Access Compliance Report

Public Rights-of-Way

Intersection ID: N/A	Main Street: BROOKSVALE_ST	Cross Street: N/A	Location: SW
ADA ID: CE2AF572AA65	Ramp Type: Perp	Initial Pass/Fail: Fail	Overall Compliance: No
Severity Score: 12.5			
Codes/Mitigation Info/Possible Solution		Field Measurements/Component Compliance

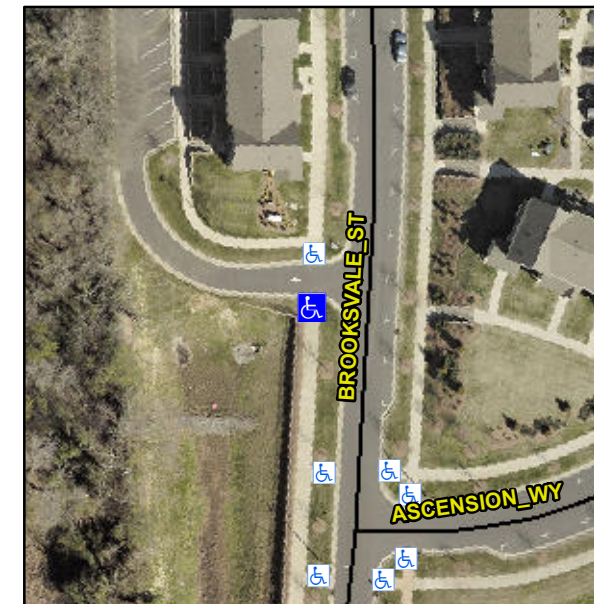
Compliance	Description	Data	Compliance	Description	Data
N/A	Ramp Length (in)	72.0	No	Ramp Slope (%)	8.5
Yes	Ramp Width (in)	94.0	Yes	Ramp XSlope (%)	0.2
N/A	Flare Type LT	N/A	N/A	Flare Type RT	N/A
N/A	Flare Slope LT (%)	N/A	N/A	Flare Slope RT (%)	N/A
N/A	Flare Traversable LT?	N/A	N/A	Flare Traversable RT?	N/A
N/A	Landing Length (in)	N/A	N/A	DWS Provided?	N/A
N/A	Landing Width (in)	N/A	N/A	DWS Contrast?	N/A
N/A	Landing Slope (%)	N/A	N/A	DWS Length (in)	N/A
N/A	Landing X Slope (%)	N/A	N/A	DWS Full Width?	N/A
N/A	Landing Curb? (Y/N)	N/A	N/A	DWS Offset (in)	N/A
N/A	Shared Landing?	N/A			
N/A	Gutter Ponding?	N/A	N/A	Gutter Slope (%)	N/A
N/A	Gutter Lip Ht (in)	N/A	N/A	Gutter X Slope (%)	N/A
N/A	Painted X Walk1?	No	N/A	Painted X Walk2?	N/A
	X Walk 1 Direction	To N		X Walk 2 Direction	N/A
N/A	X Walk 1 Width (in)	N/A	N/A	X Walk 2 Width (in)	N/A
	X Walk 1 Slope (%)	1.9		X Walk 2 Slope (%)	N/A
	X Walk 1 X Slope (%)	0.8		X Walk 2 X Slope (%)	N/A

Remove & Replace Entire Ramp.

R304.2.2
